City of  
Richmond

## Report to Development Permit Panel

**File:** DP 11-564405

**Re:** **Application by Dava Development Ltd. for a General Compliance Ruling at Portions of 10111, 10197 & 10199 River Drive (formerly Portions of 10111 & 10199 River Drive)**

Annotated Approved DP Plan 3

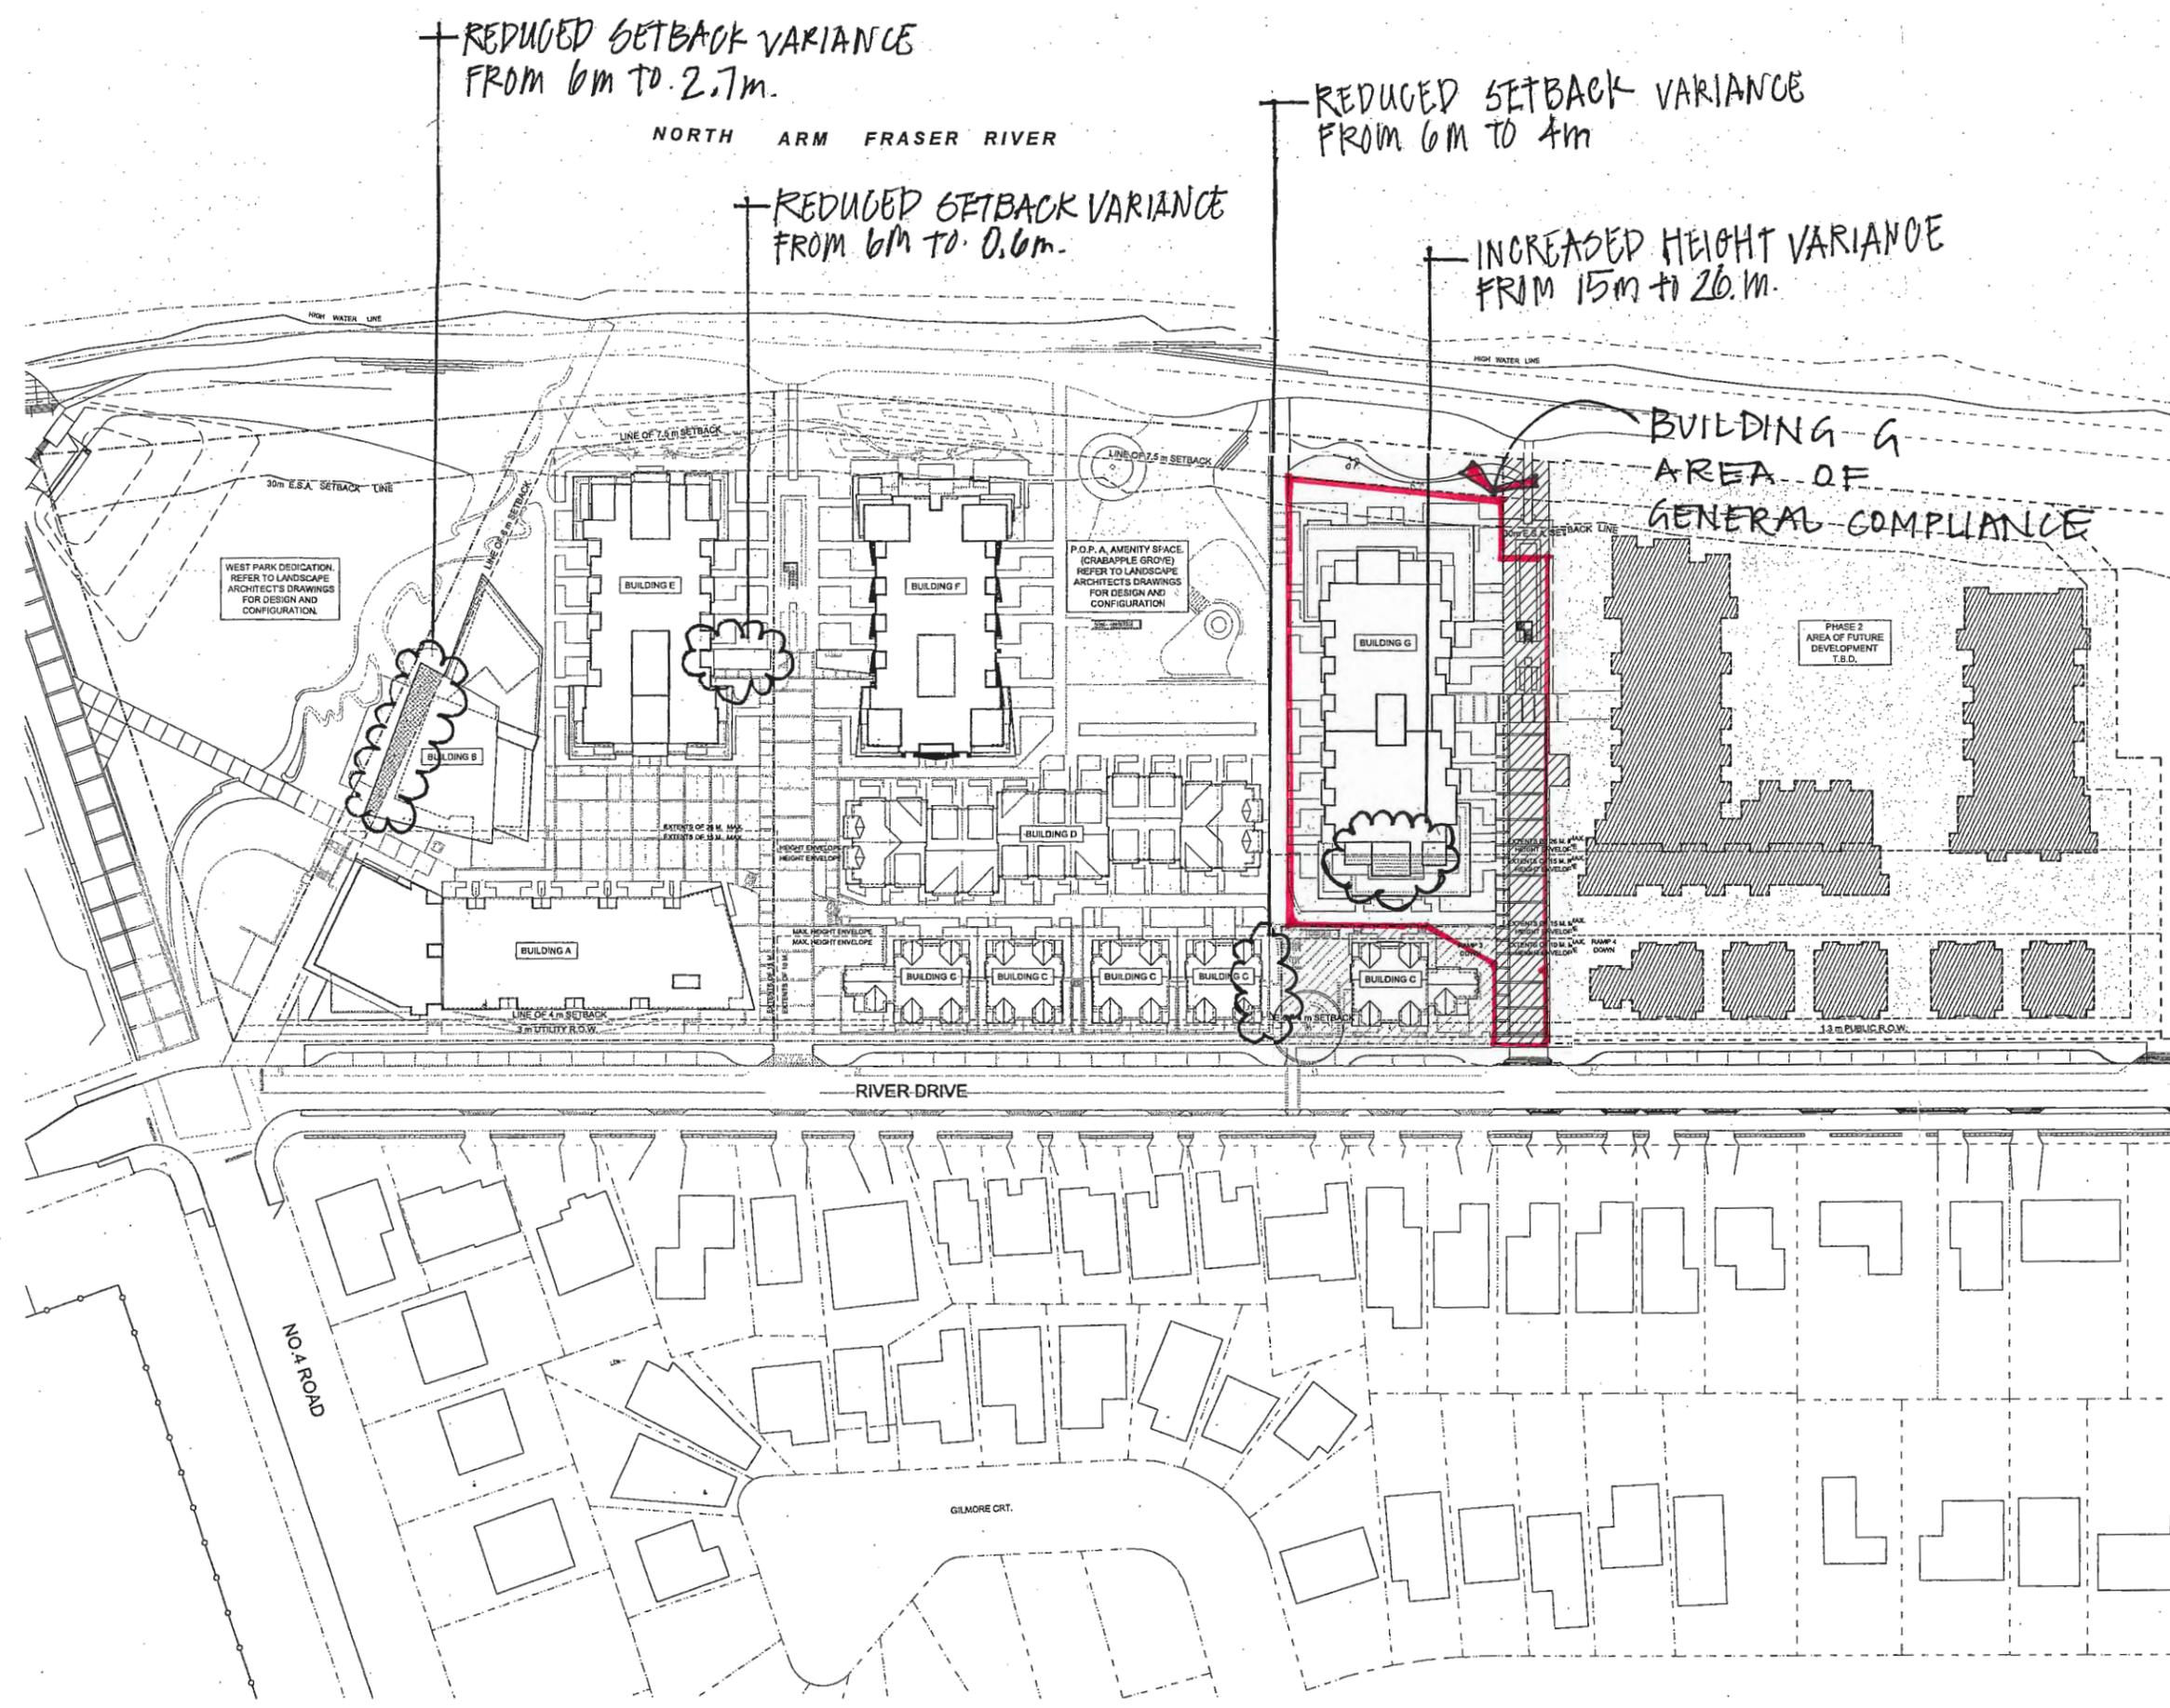
BUILDING G AREA OF GENERAL COMPLIANCE

Plan 3c Sept 15, 2016 DP 11-564405

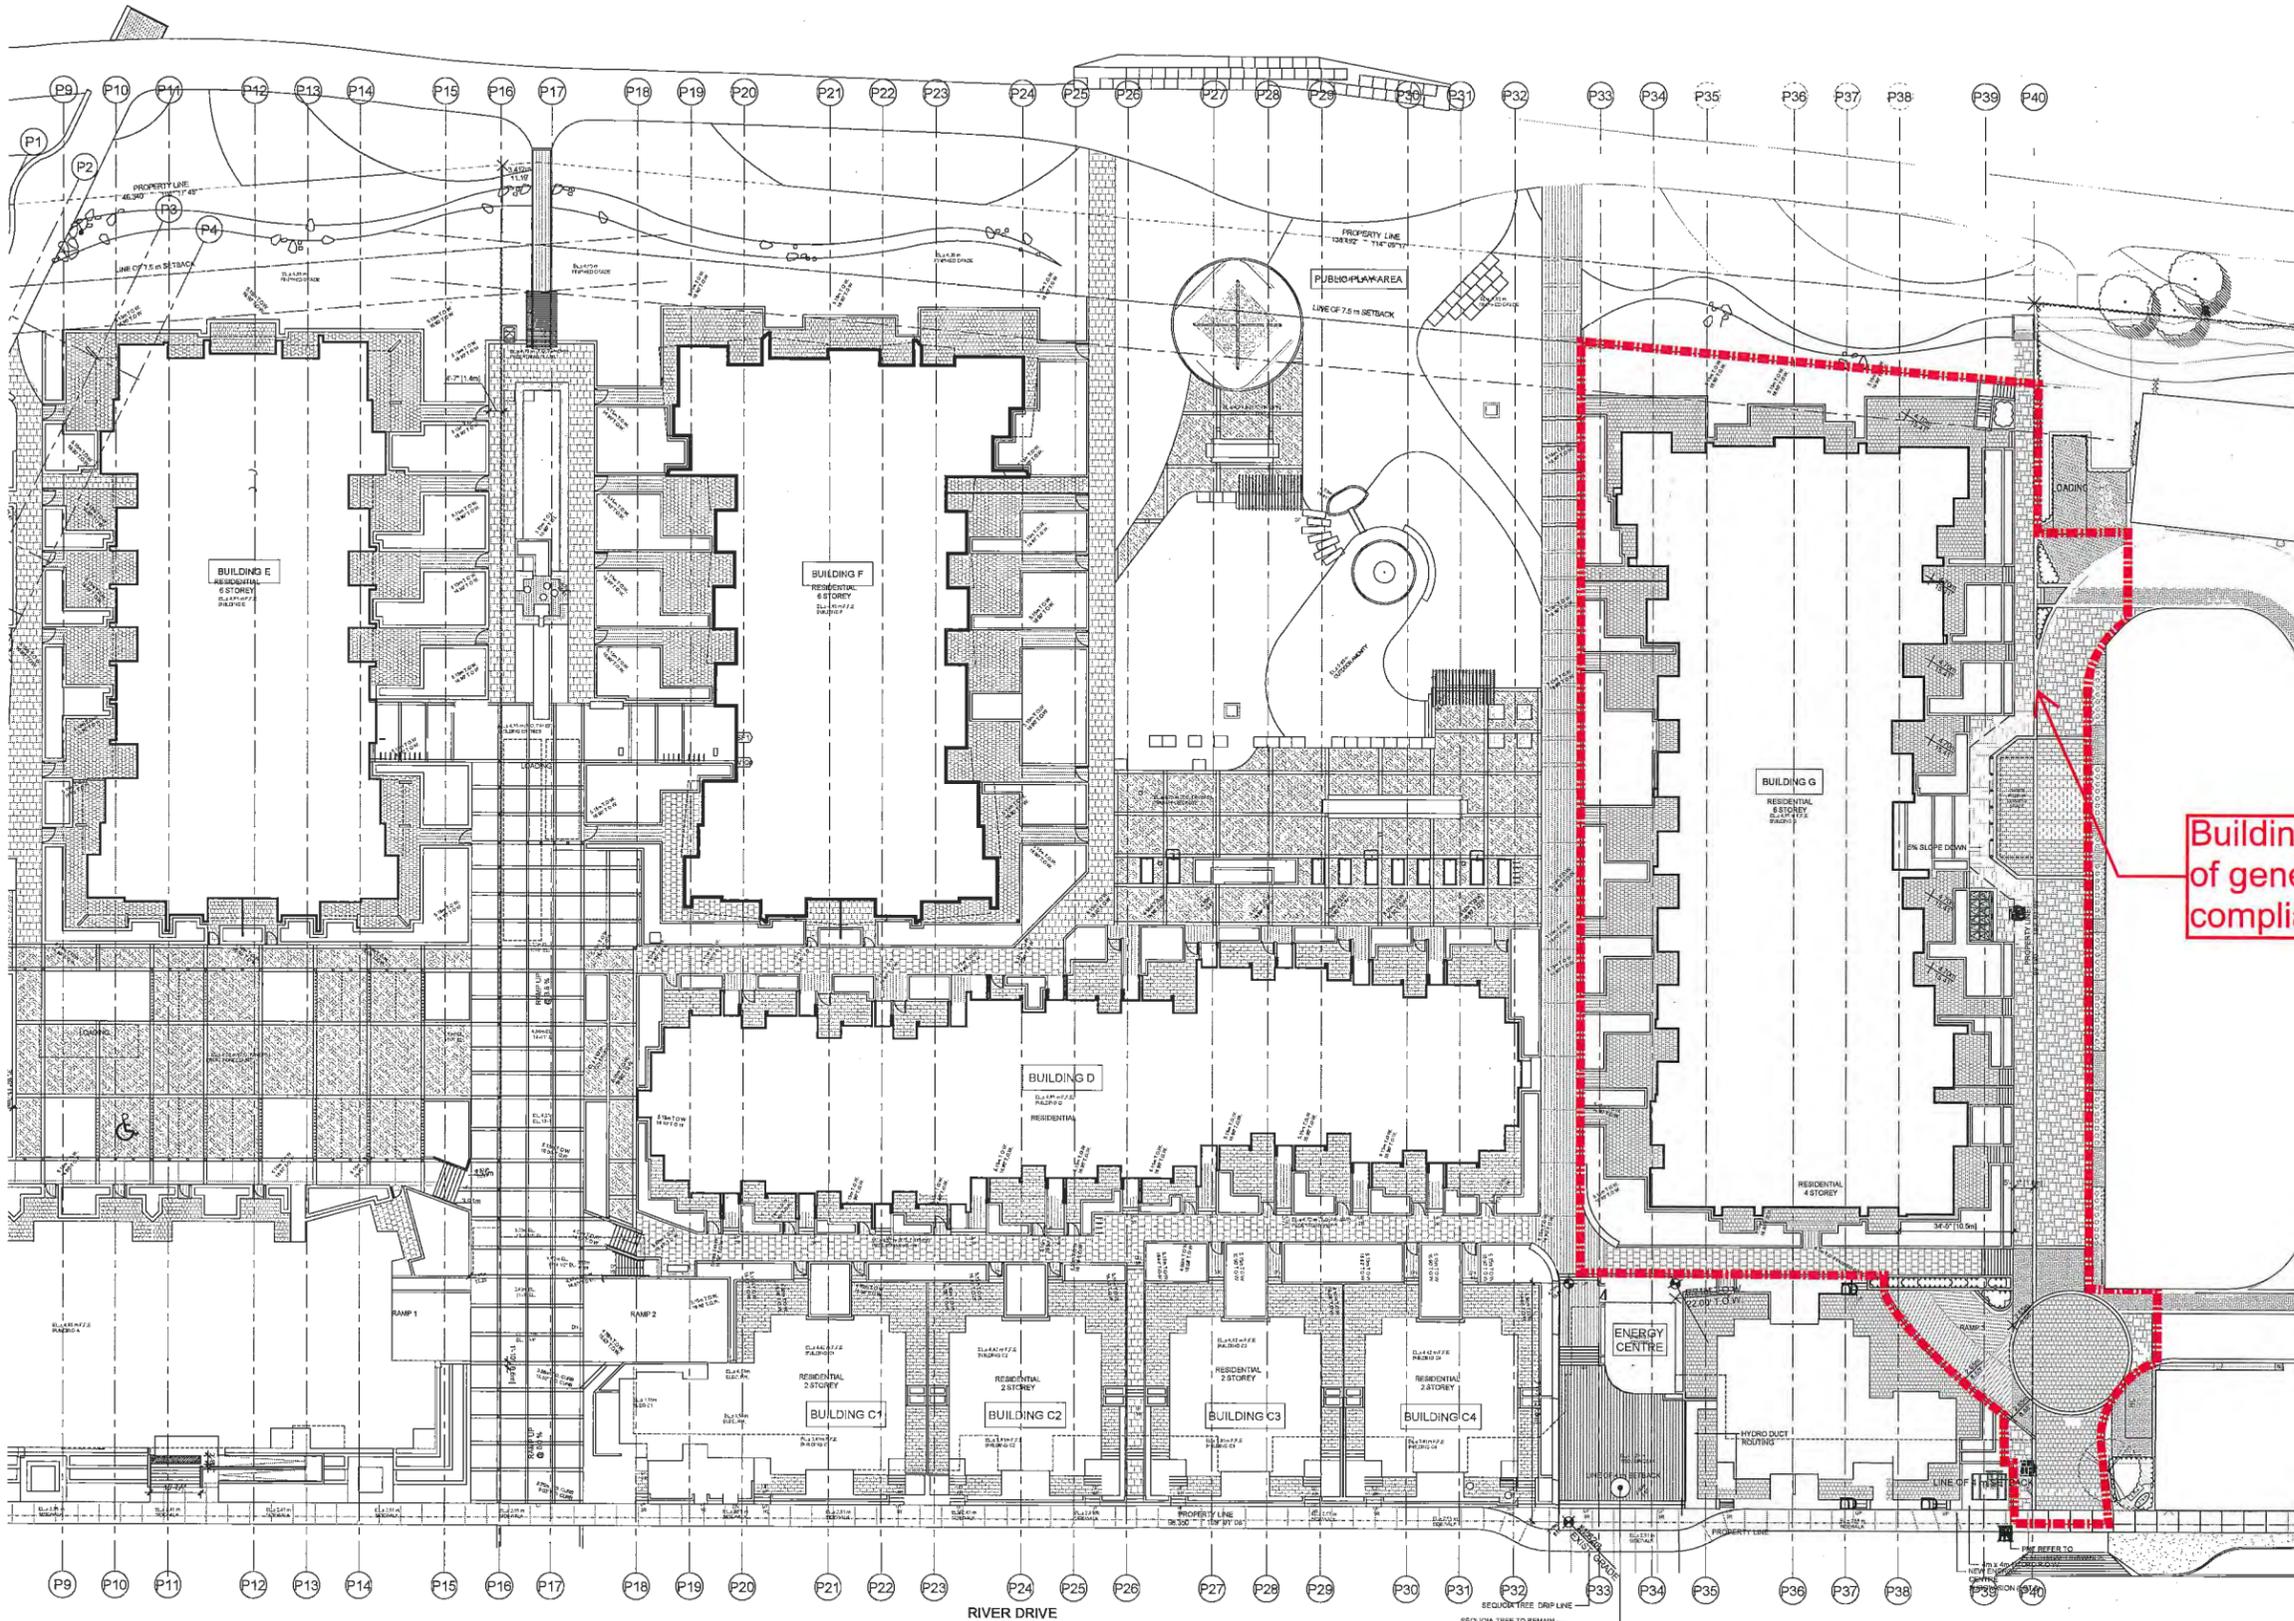
Supplements Plan 3 to identify area of revisions at Building G and drive aisle

Building G area of general compliance

Plan 5a Sept 15, 2016  
 DP 11-564405

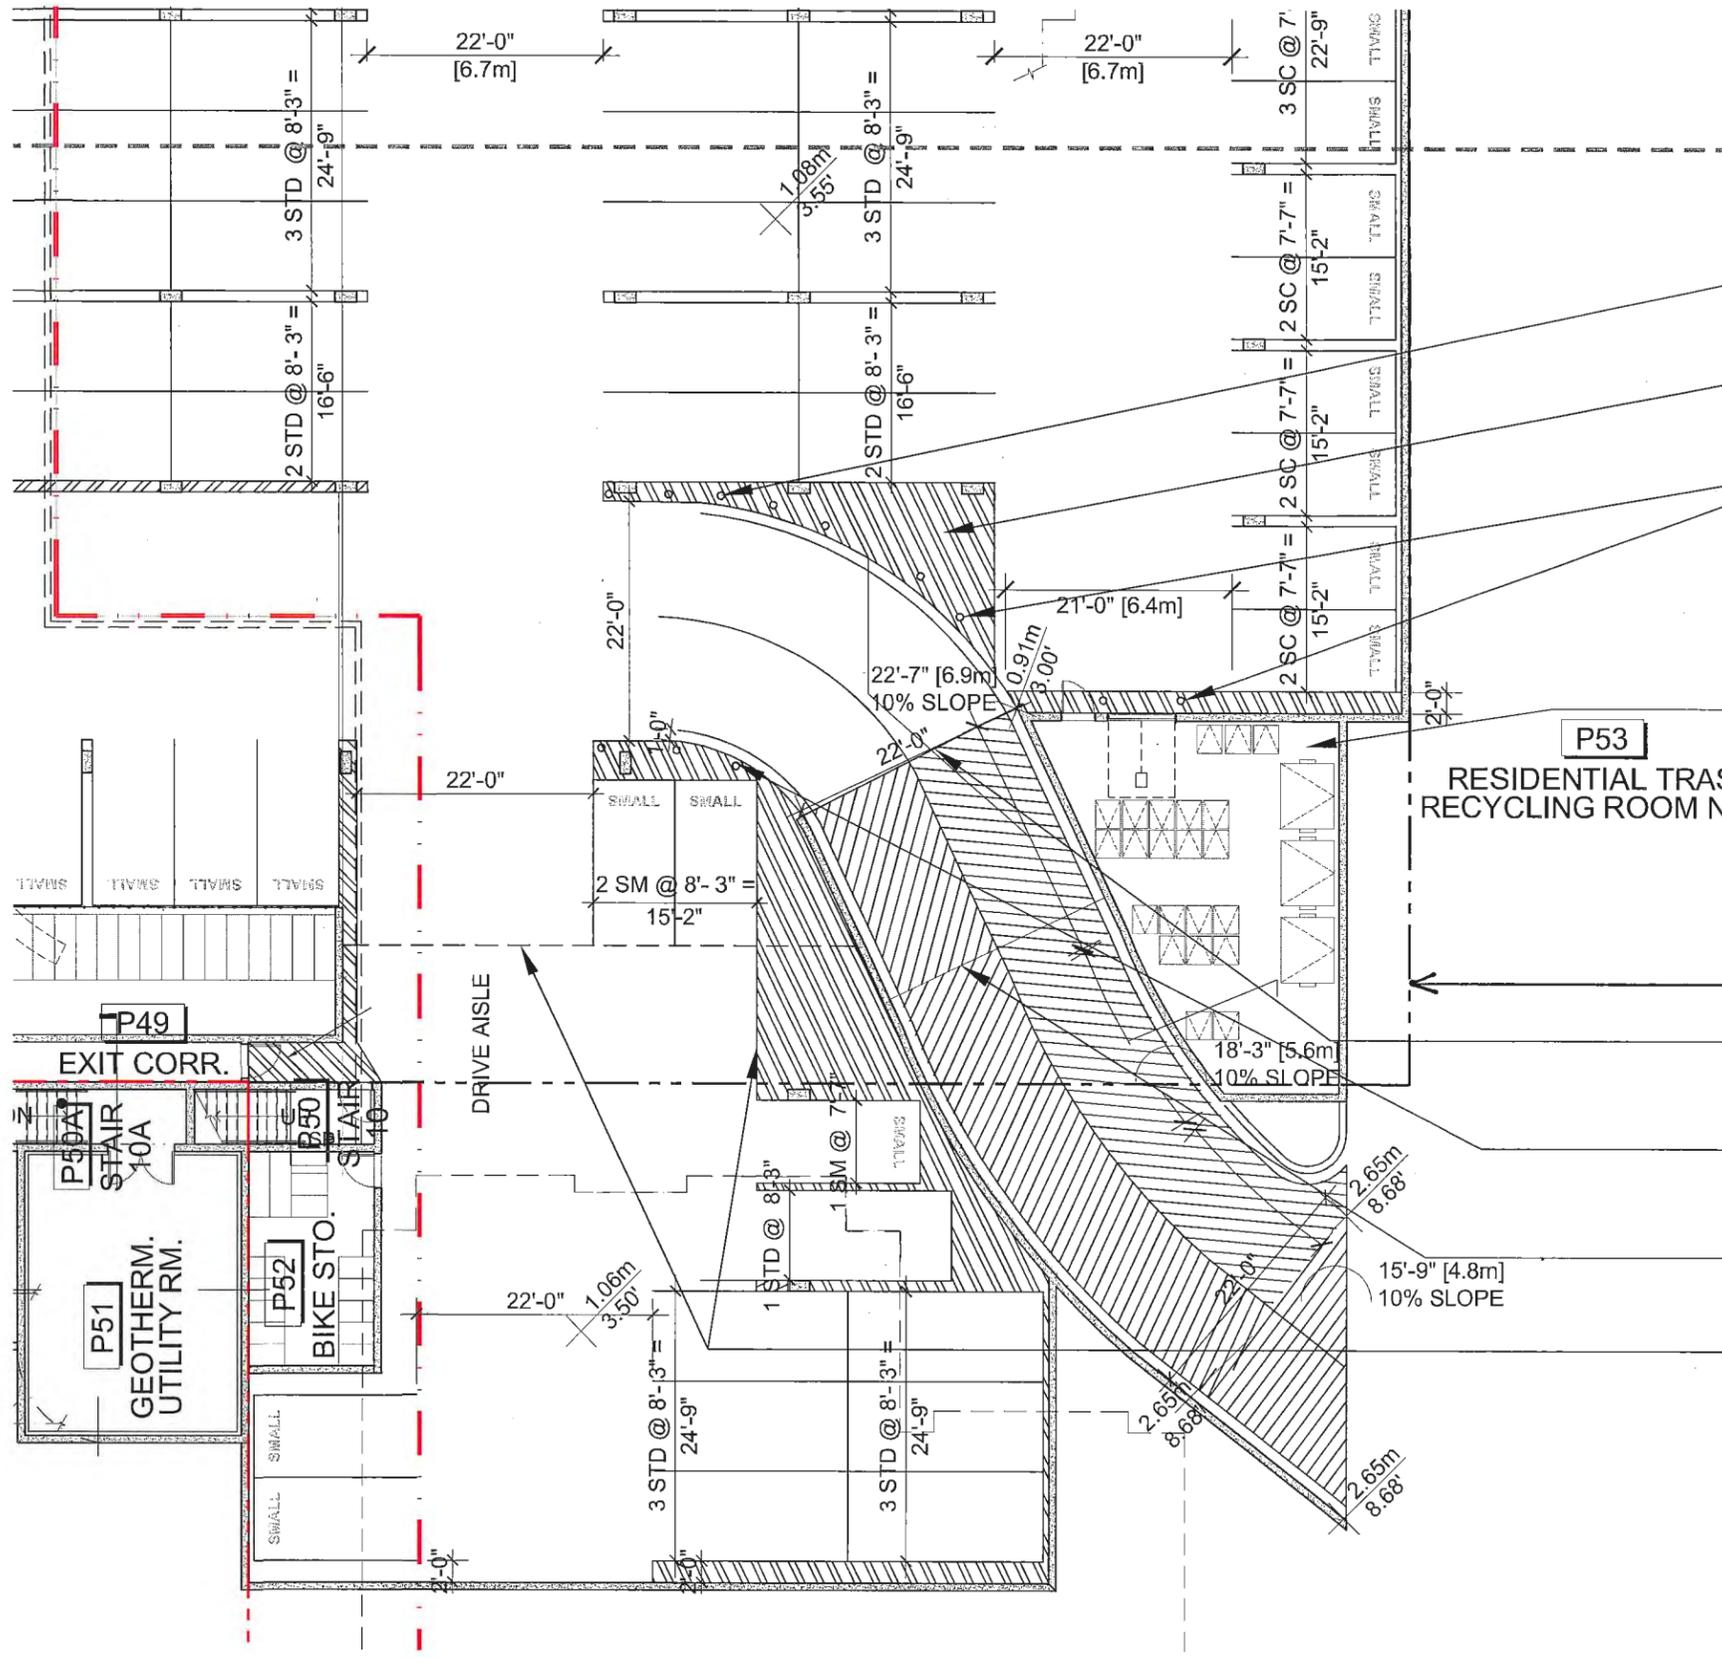
Supplements Plan 5 with revised ramp and parking layout at Building C5 and G

- The parkade entry ramp located between building “G” and building “C5” and the parking layout inside the underground parkade have been revised to locate the resident parking for building “C5” underneath building “C5” and to provide a setback to accommodate an appropriate grade transition to the neighbouring future Phase 2 development. A required pedestrian exit has also been added at the northeast corner of the parkade.

- The revised parking layout for building “C5” includes six (6) tandem parking spaces. Registration of a legal agreement requiring tandem parking spaces to be assigned to the same unit is a consideration of the General Compliance approval.
